Applying Errata ID 4080 to MPC5604E Evaluation Board

The purpose of this engineering bulletin is to describe how to apply errata 4080 to MPC5604E Evaluation Board. This errata describe issue where device cannot come out of reset till V_{DD_LV} is less than a threshold value. This document is valid for evaluation boards where device with mask 0N10D is installed and board is not marked with a TDA4008 label.

Figure 1. Input core supply voltage regulator implemented on MPC5604E EVB

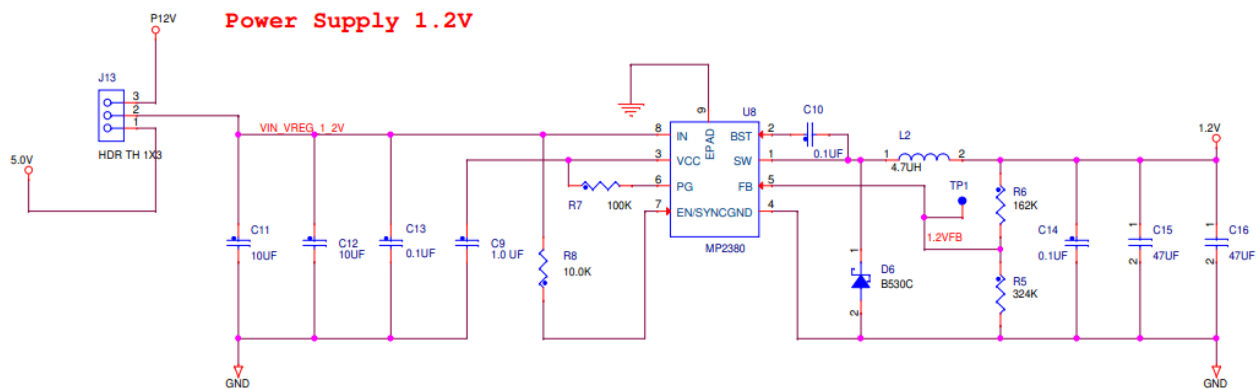
Errata 4080 is relevant for external supply regulation mode of the device. There is a requirement for input core supply voltage V_{DD_LV} to be 1.24V at the startup time otherwise the device might get stuck in reset.

Low voltage power supply is designed to produce 1.20V which does not meet requirement mentioned above. Low voltage power supply consist of MP2380 monolithic step-down switch mode converter where output voltage is controlled via external resistor divider. The schematic below shows implementation of MP2380 at MPC5604E evaluation board. The external resistor divider consist of resistors R6 and R5.

Originally V_{DD_LV} is 1.20V which correspond to the schematic and the following equation:

Based on Errata 4080 requirement we have to change value or R5 to achieve $V_{DD_LV}=1.24V$ as given below:

Recommended solution for MPC5604E evaluation board is to change value of R5 resistor from original value 324kΩ to new value 294kΩ.
